Core Bus Corridor 9: Greenhills - Preliminary Submission

1.0 Introduction

A demonstration of how the proposed junction design does not enable cycling for people of all ages and all abilities

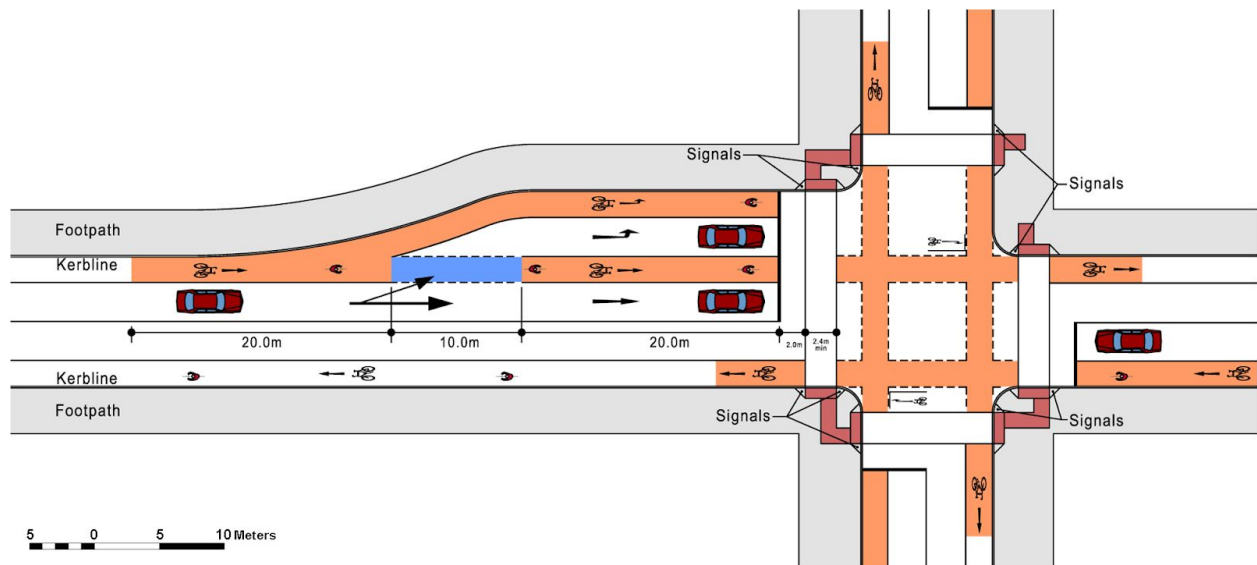
1. The shallow angle of crossing means that cyclists have to look backwards to check that it is safe to proceed. This can be difficult and dangerous at busy junctions, especially for more vulnerable cyclists.
2. The lack of protection means that cyclists are at risk of being hit by a driver moving into the left turn lane. This risk is particularly pronounced with HGVs which often have large blind zones.
3. Drivers often merge gradually over the entire length of the streaming lane, instead of moving into the left turn lane as quickly as possible. This exacerbates the problems highlighted in the previous two points.
4. The perception of danger that this junction design creates means that it will not encourage cycling for all. The image below shows why inexperienced cyclists do not feel comfortable using junctions like these.

As well as being dangerous for cyclists, the proposed streaming lanes do not comply with the National Cycle Manual (NCM). Section 4.4.4 of the NCM states that:

1. *Streaming cycle lanes can only be used in low traffic speed environments where there is minimal speed differential between cyclists and adjacent traffic*
2. *Streaming is not suitable along HGV routes*
3. *The permitted weaving area for traffic to cross the cycle lane must be clearly indicated and limited to no more than 10.0m long so as to reduce vehicular speed, and profiled line markings should be considered for the solid white line beyond the weaving area.*
4. *Streaming cycle lanes should only be used beside right or left hand pockets (i.e. distinct lanes dedicated to turning movements) and should not exceed 30.0m in length*
5. *Cycle lanes should be clearly visible in all conditions, including night time and poor weather.*

With a speed limit of 50 kph for much of the corridor, this is not a low speed route, so the streaming lanes are not compliant with point 1, especially on the suburban sections of the corridor.

- Airton Road: 61 m streaming lane, including a 21.5 m weaving area.
- Mayberry Road: 62 m streaming lane, including a 27 m weaving area.
- Drimnagh Road: 29 m streaming lane, all of which is a weaving area.
- Dean Street: 29 m streaming lane, all of which is a weaving area.
- Nicholas Street: 33 m streaming lane, with no marked weaving lane. The weaving lane would be 19-25 m long if marked, bringing the total streaming length to 52-58 m.

For these reasons, we recommend that all the proposed streaming lanes be removed. Replacing these junctions with either NCM compliant junction designs or by using the protected junction designs from above.

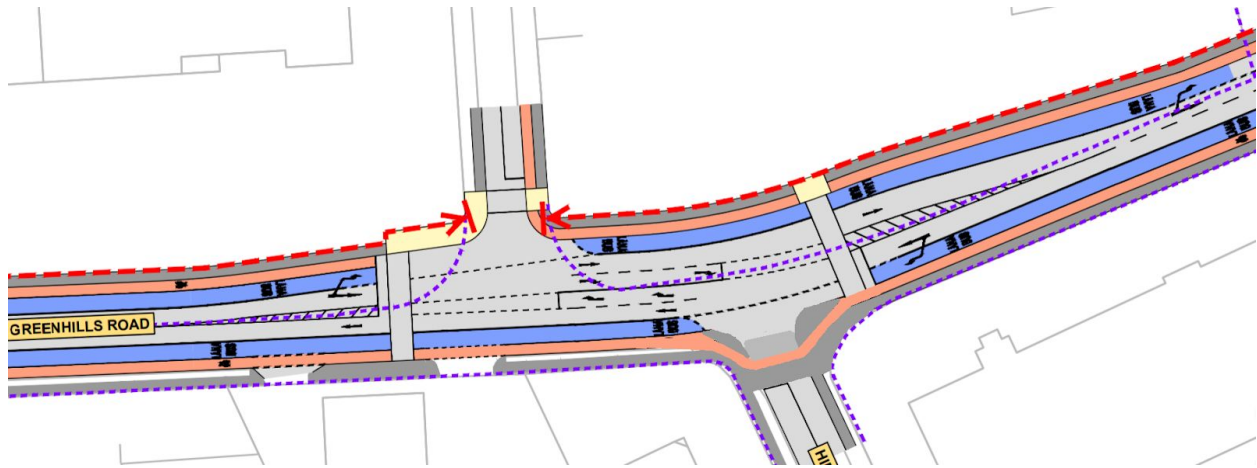
The proposed layout of the junction at the Greenhills Road entrance to ITT does not cater for cyclists exiting right, or entering from the north, and will create pedestrian/cyclist and bus/cyclist conflicts. The detailed design needs to take these factors into account.

- The existing cycle tracks on Greenhills Road south of the ITT entrance should be retained and improved further. Further, the northbound track should be redesigned to maintain priority across the ITT Access Road.
- The southbound cycle track should continue through the T junction. This is especially important at this junction because the large number of lane merges and the lack of space would cause drivers to encroach on a painted cycle lane.
- An additional pedestrian/cycle crossing should be installed so that all arms have a pedestrian crossing.

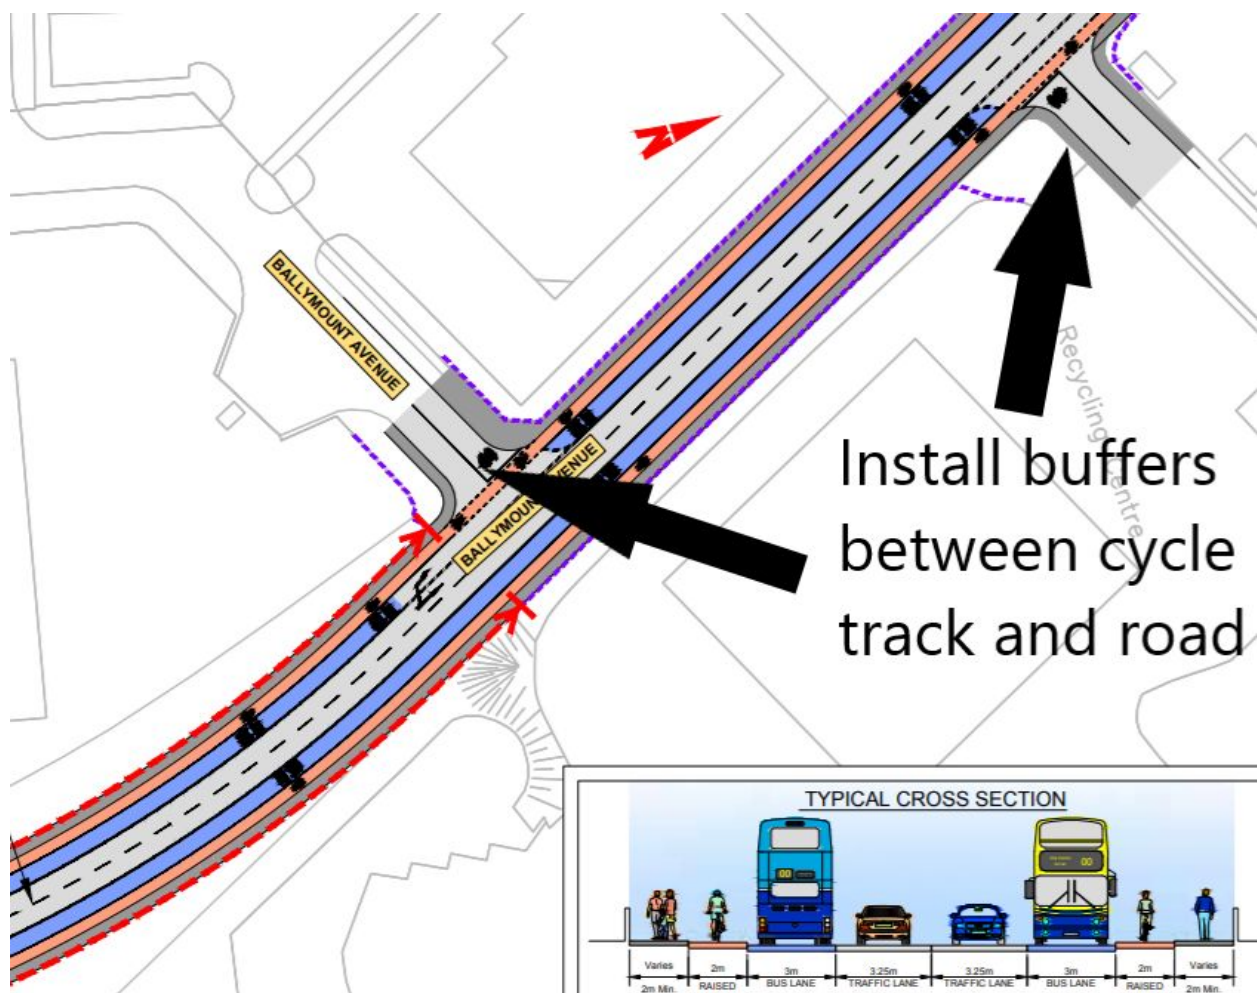
We recommend the clear delineation of a cycle/pedestrian link from the old Greenhills Road to the proposed Toucan crossing on Map 9. This will make it safer and easier for cyclists to access the Greenhills route heading northwards, as well as facilitating cross access by pedestrians.

Alternate design for junction (map 13)

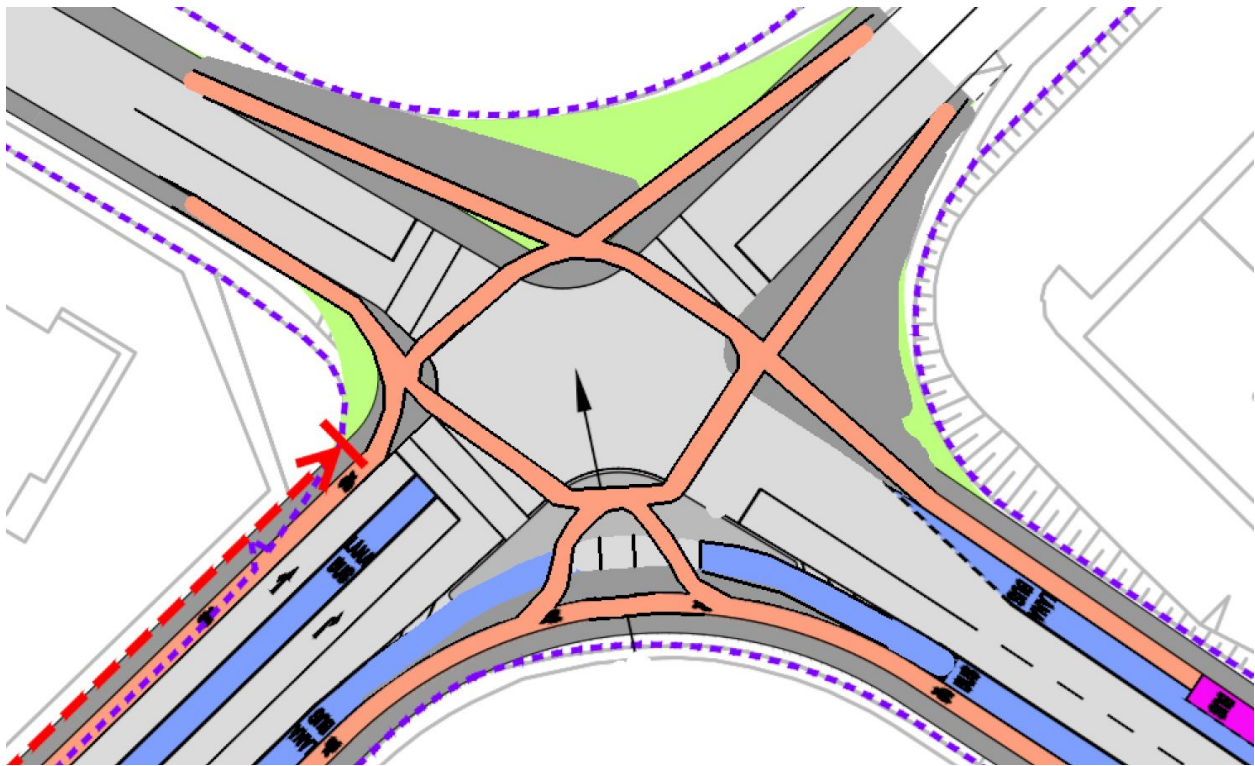
We welcome the removal of the roundabout at this junction. However, it is disappointing that the proposed replacement, as outlined in the drawing (Map 13) is little better for cyclists. All four arms of this junction are Secondary Routes in the GDA Cycle Network Plan, so it needs to be possible for cyclists to make all possible turning movements. We await details of the final detailed design in this area.

There's more than enough space for full Dutch style junction. While we would like to see the busy slip road removed, as it poses a danger for cyclists. The image below would be a possible workable compromise, with space between the cycle track and the bus slip lane

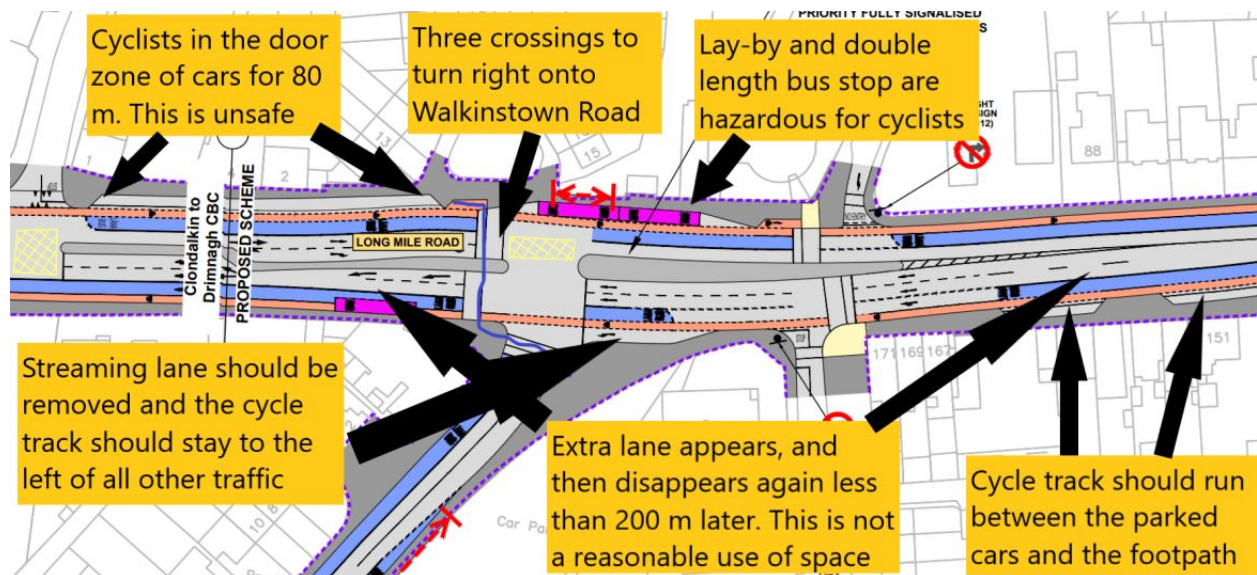
The junction between Bunting Road and Cromwellsfort Road is not at all safe for cyclists. For outbound cyclists, the cycle track suddenly disappears just before the

junction. Inbound cyclists also inexplicably lose their cycle track at the bend. It is not clear how an outbound cyclist on Bunting Road can rejoin the cycle tracks on Greenhills Road. How does a cyclist make a right turn?

3.13 Crumlin Road (Maps 30, 31)

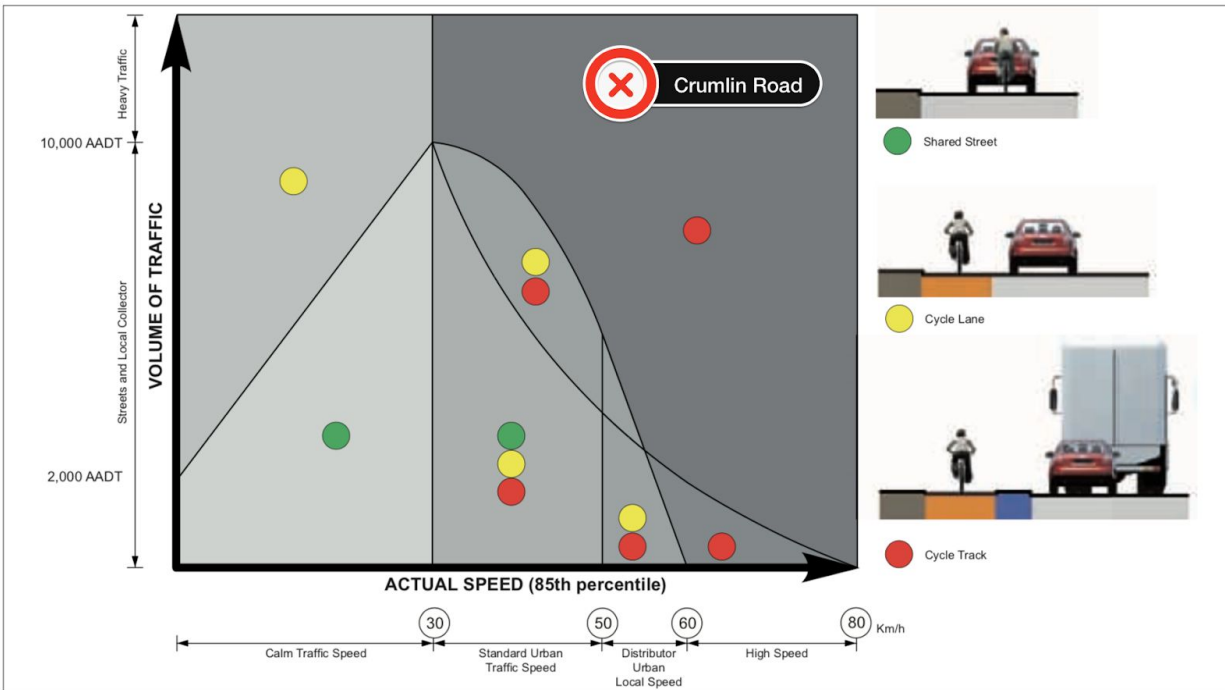
Crumlin Road from Sundrive Road to the Grand Canal (map 30-31) has no dedicated cycle facilities. The options report recognises that this stretch forms part of Primary Route 8 in the GDA Cycle Network Plan, yet no efforts were made to find space for cycle tracks here.

The options report begins with the unbending assumption that a bus lane and a general traffic lane must be maintained in both directions, even though DMURS states that these two modes should be considered last, not first.

The proposals to reduce the speed limit to 30km/h between Herberton Road and Dolphin Road, are a misreading of the National Cycle Manual (NCM). Are the schools the reasoning behind the lower speed limits on this section? The NCM uses actual traffic speeds and traffic flow to determine whether dedicated cycle facilities are required. No part of the suggested proposals will reduce the speed of traffic. Signage has limited effectiveness, as demonstrated by RSA regular free speed surveys.

1. Provide cycle tracks for the first 200m of that section of road at either end where the space already exists
2. Commit to a full CPO. Roughly 3m of space needs to be found to provide minimum width facilities. This would reduce the general traffic lanes from 3.25m to 3m and provide 1.75m cycle lanes.

3. Remove a traffic lane and re-route inbound traffic via Herberton Road and the Canal back to Dolphins Barn bridge. This will require the junction at Crumlin Road/Sundrive to be redesigned to include a dedicated left-turn lane.

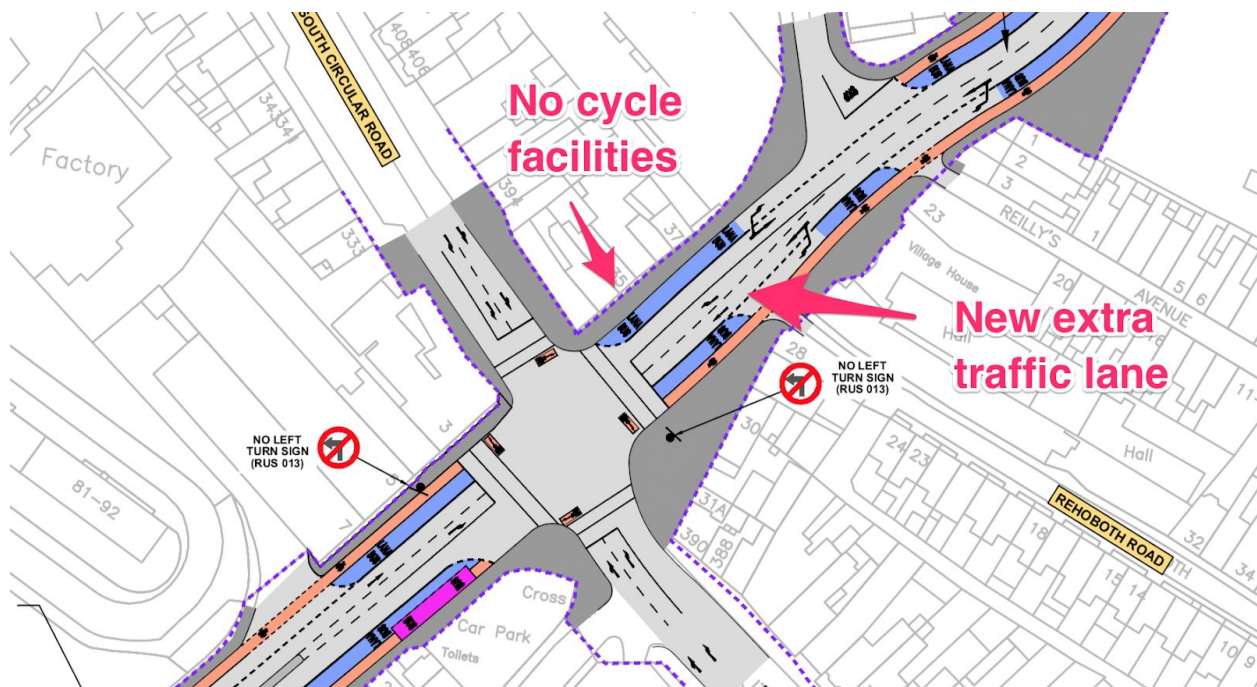
The cycle tracks on Dolphins Barn Bridge over the canal look less than 2m. The hatching down the middle of the bridge should be removed to provide any necessary width for the cycle facilities.
